**Request for Additional Information No. 20, Revision 0**

**7/28/2008**

**U.S. EPR Standard Design Certification**

**SRP Section: 09.05.01 - Fire Protection Program**

**Figure 9.5.1-1—Fire Water Distribution System  
Sheet 1 of 13**

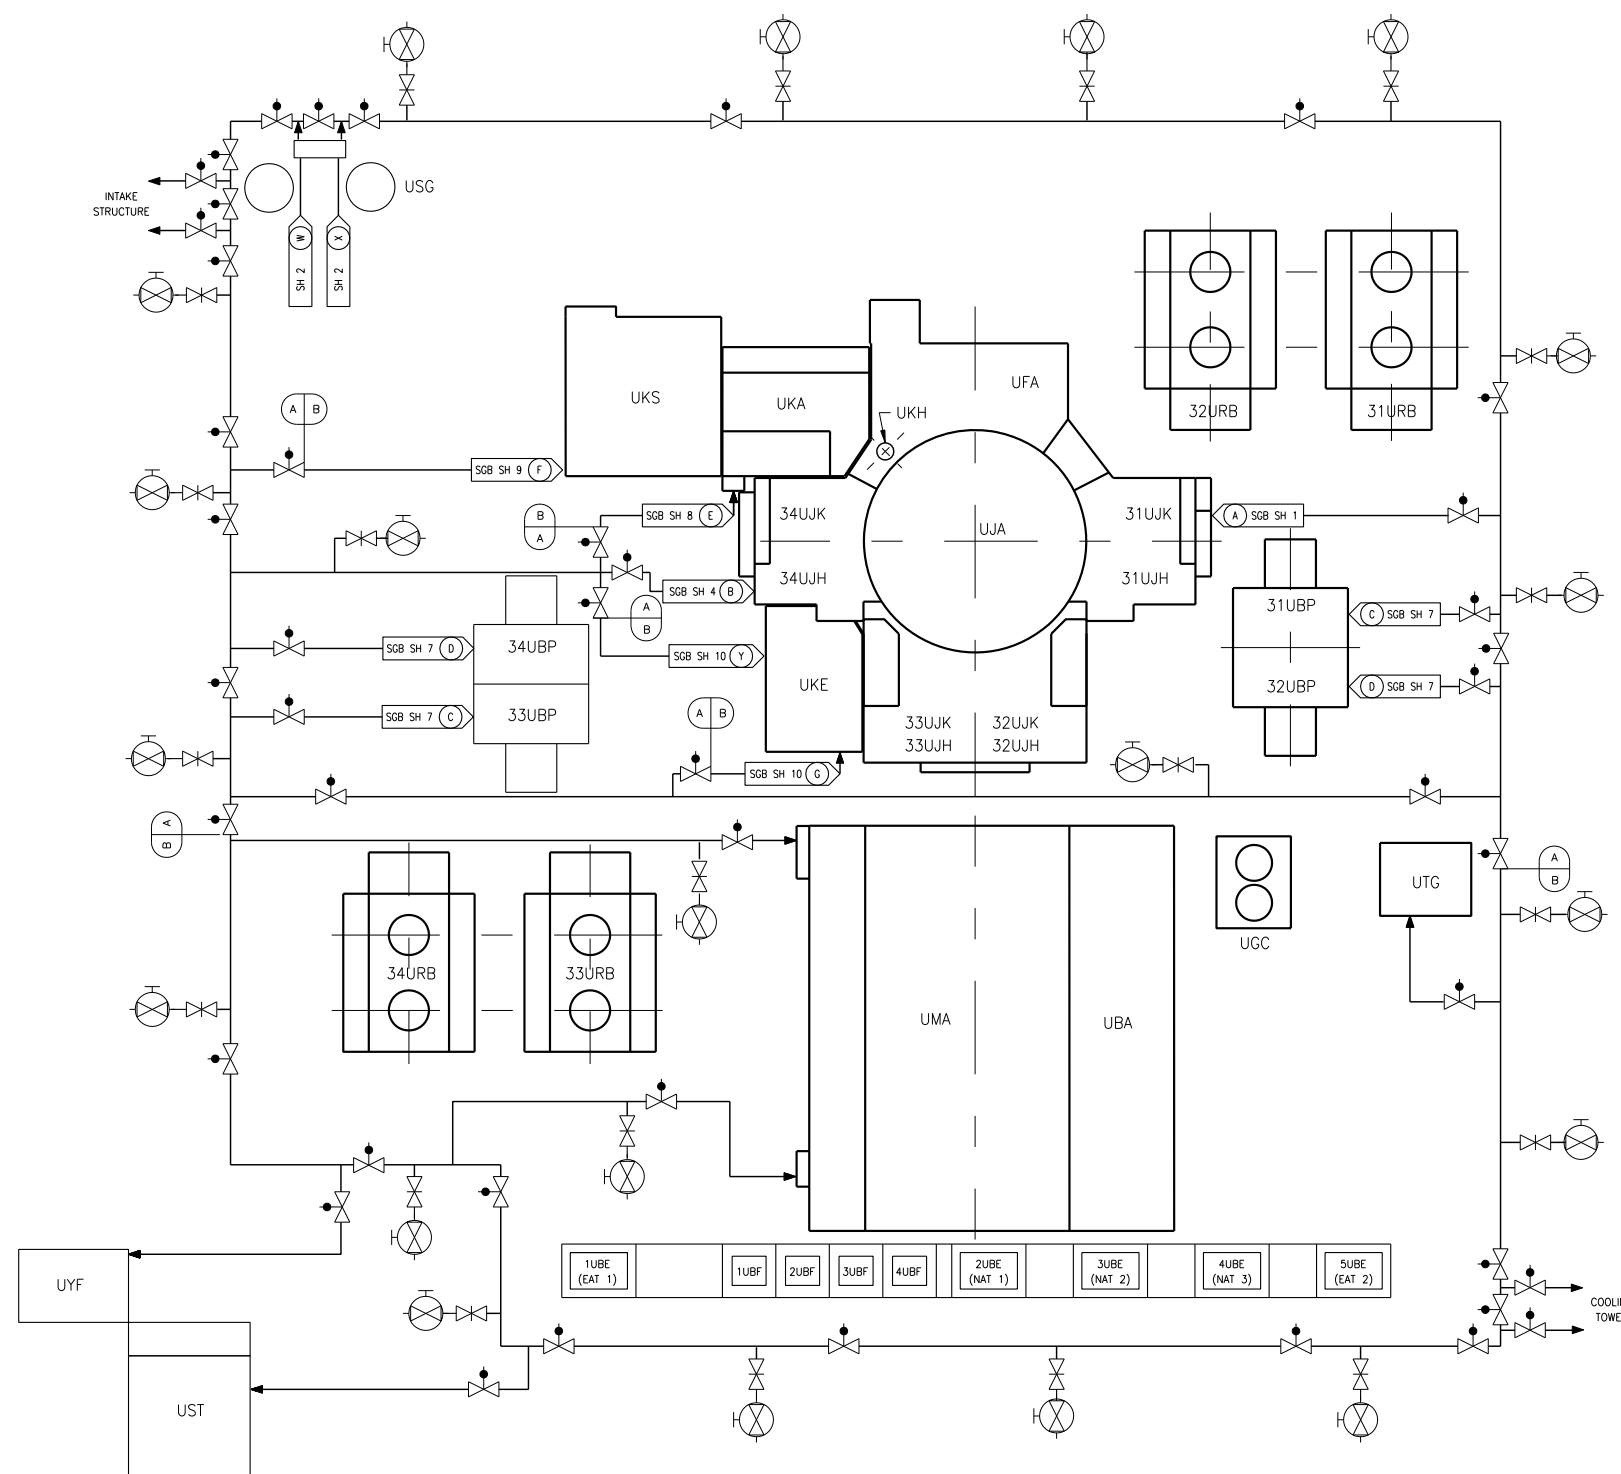
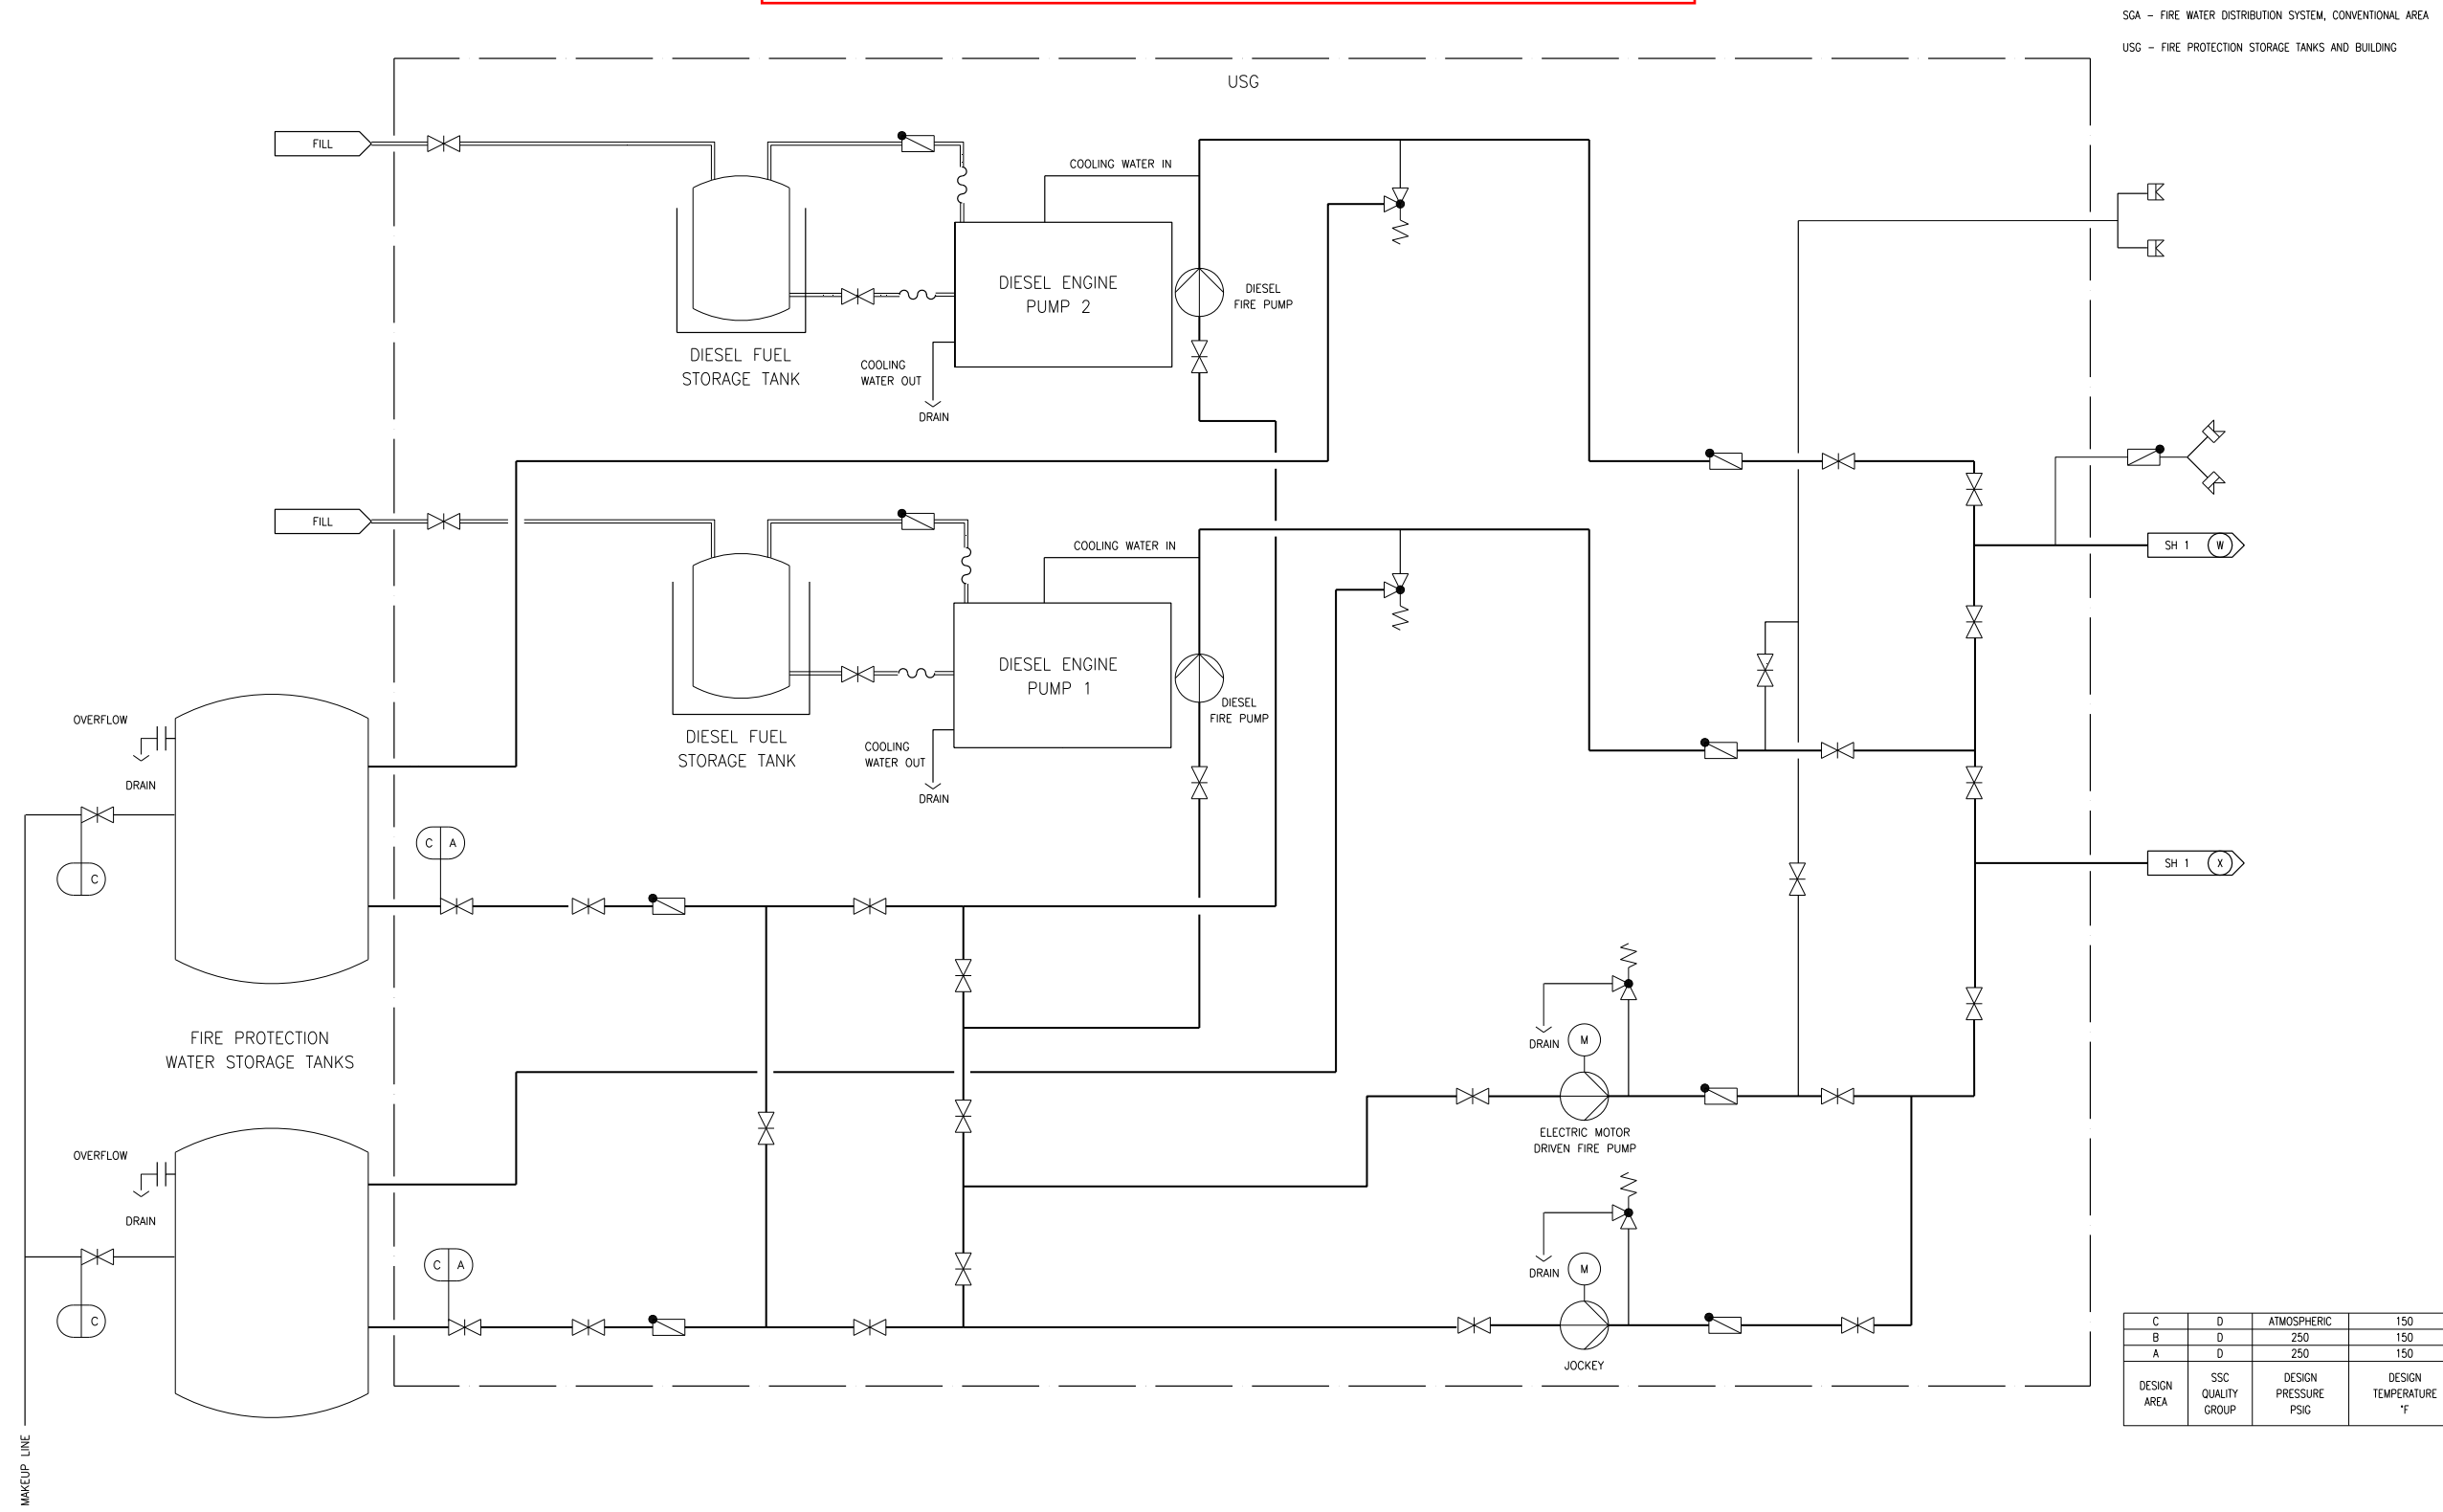
The EPR FSAR should add a COL information item to provide simplified FPS piping and instrumentation diagrams showing complete site-specific systems. Nuclear Island definition is different in Figure 9.5.1-1 then in Tier 1 Section 2.1.1. Modify FSAR accordingly. Basis: Completeness of application.

U.S. EPR FSAR Tier 2, Figure 9.5.1-1 depicts the fire water distribution system for the Nuclear Island (NI) and plant areas not considered part of the NI. However, the current title for this figure is "Fire Water Distribution System Inside Nuclear Island."

The title for U.S. EPR FSAR Tier 2, Figure 9.5.1-1 will be changed to "Fire Water Distribution System." The reference to this figure in U.S. EPR FSAR Tier 2, Section 9.5.1.2.1, under "Fire Water Supply System," will be revised to reflect the new title identified above.

U.S. EPR FSAR Tier 2, Section 9.5.1.2.1 will be revised as described in the response and indicated on the enclosed markup. U.S. EPR FSAR Tier 2, Figure 9.5.1-1 will be revised as described in the response and indicated on the enclosed markup. U.S. EPR FSAR Tier 2, Table 1.8-2 will be revised as described in the response and indicated on the enclosed markup.
